SUNDRY NOTICES AND REPORTS ON WELLS

Jenkins AXI Federal Com #1

Yates Petroleum Corporation wishes to extend the captioned well's APD for two (2) years to September 18, 2011.
H2S is not anticipated.
C-102 Attached.
Previously Approved.

PECOS DISTRICT CONDITIONS OF APPROVAL

Crowning

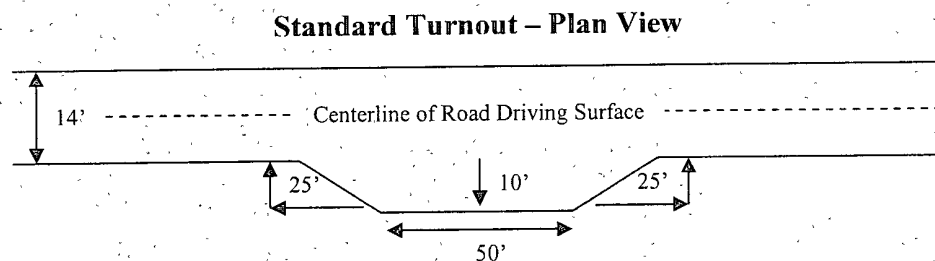
Crowning shall be done on the access road driving surface. The road crown shall have a grade of approximately 2% (i.e., a 1" crown on a 14' wide road). The road shall conform to Figure 1; cross section and plans for typical road construction.

Cross Section of a Typical Lead-off Ditch

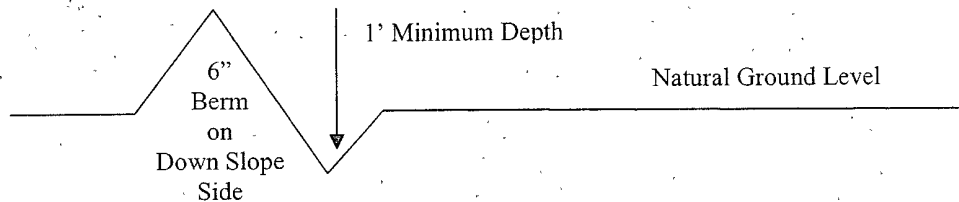
A typical lead-off ditch has a minimum depth of 1 foot below and a berm of 6 inches above natural ground level. The berm shall be on the down-slope side of the lead-off ditch.

All lead-off ditches shall be graded to drain water with a 1 percent minimum to 3 percent maximum ditch slope. The spacing interval are variable for lead-off ditches and shall be determined according to the formula for spacing intervals of lead-off ditches, but may be amended depending upon existing soil types and centerline road slope (in %);
